Planning, Land Use and Mobility Committee
Case Report / 10.3.19 / Rev 7.16.20
DIR-2019-4531-DRB-SPP-MSP / Single Family Residence
4314 Canoga Drive
Woodland Hills, CA 91364

Project Description: New Single Family Residence
Applicant / Rep: Ashraf Hemmati c. 310.709.3854; e:ashrafmemar@gmail.com
LA City Planner: Valentina Knox-Jones: 818.374.5038; valentina.knox.jones@lacity.org
Case Leader: Lauren Coffman / PLUM Chair / l.coffman@whcouncil.org
PLUM Meeting: October 3, 2019 / First Presentation

BASEMENT FLOOR PLAN

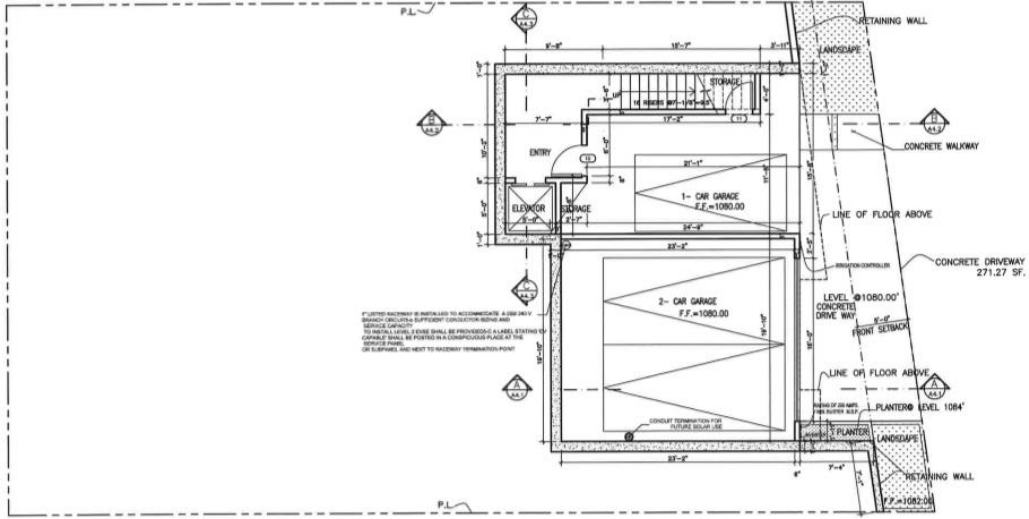
The project shows three covered spaces.

Site Plan

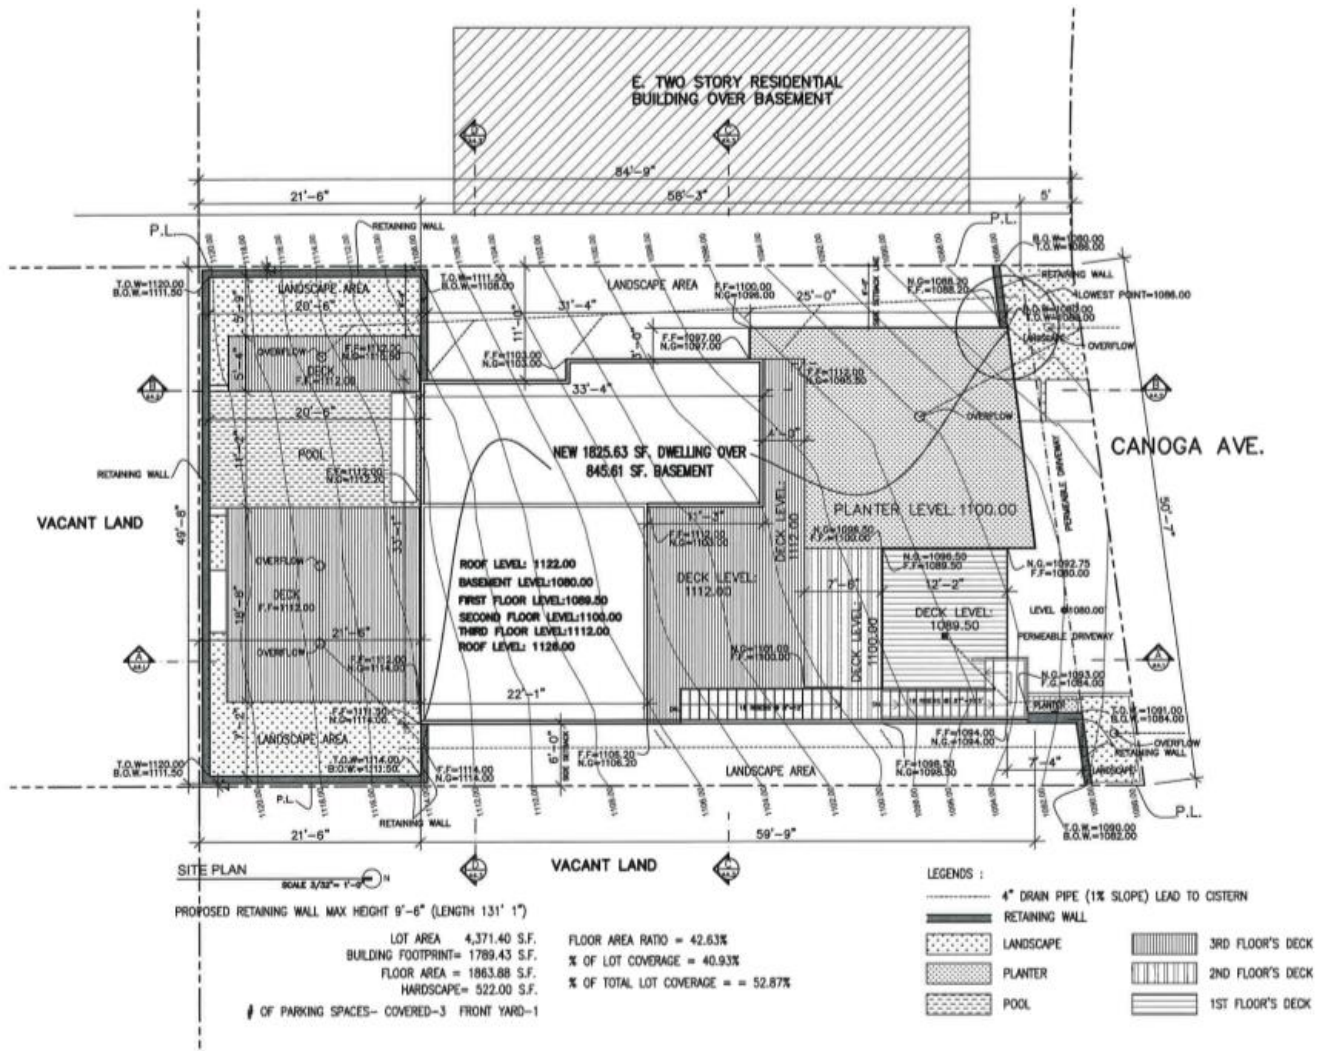
Site Drainage: Site drainage, is an issue for this site and the street, **Aside from the required planters, what is site drainage?**

Site Section

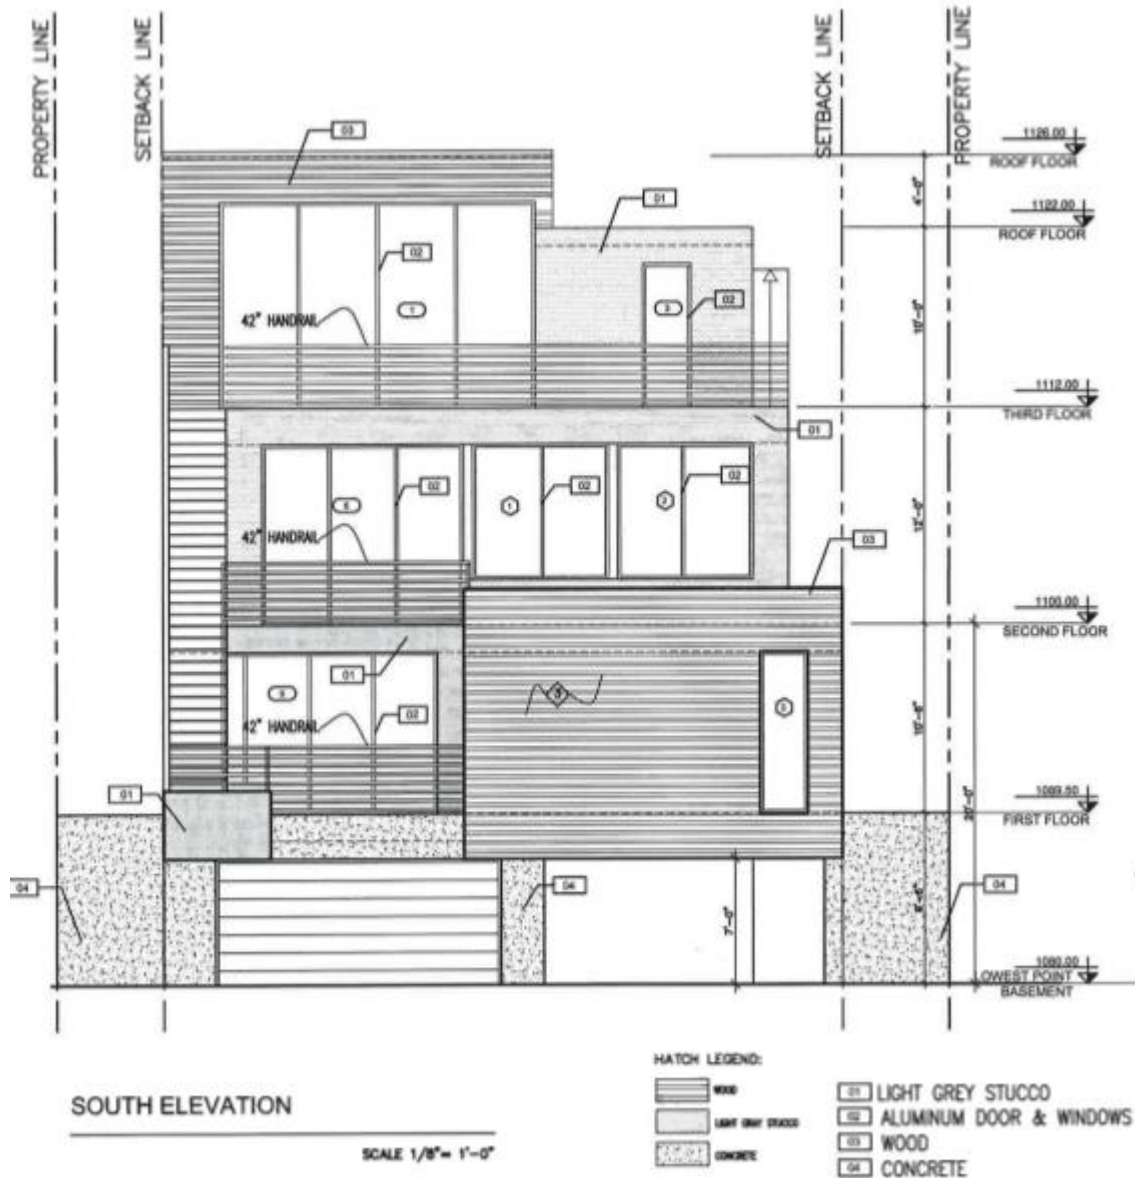
1. As per the Baseline Hillside Ordinance, the maximum envelope height for the R1-1 Zone, for a project with a roof slope less than 25% is 28 feet. This vertical height or "plumb line" height is originated at the lowest grade within 5 horizontal feet of the exterior walls of the building structure, and is the vertical distance from the grade of the site, to a projected plane at the roof structure or parapet

wall located directly above and parallel to the grade. This building height is indicated as 46' to the top of the flat roof / parapet. This building appears to be taller than allowed by the *Baseline Hillside Ordinance*.

- As per the Baseline Hillside Ordinance, on a substandard hillside street, no portion of a building or structure within 20 feet of the front yard lot line shall exceed 24 feet in height. The 24 foot height shall be measured from the midpoint of the street on which it faces. How does this building comply?
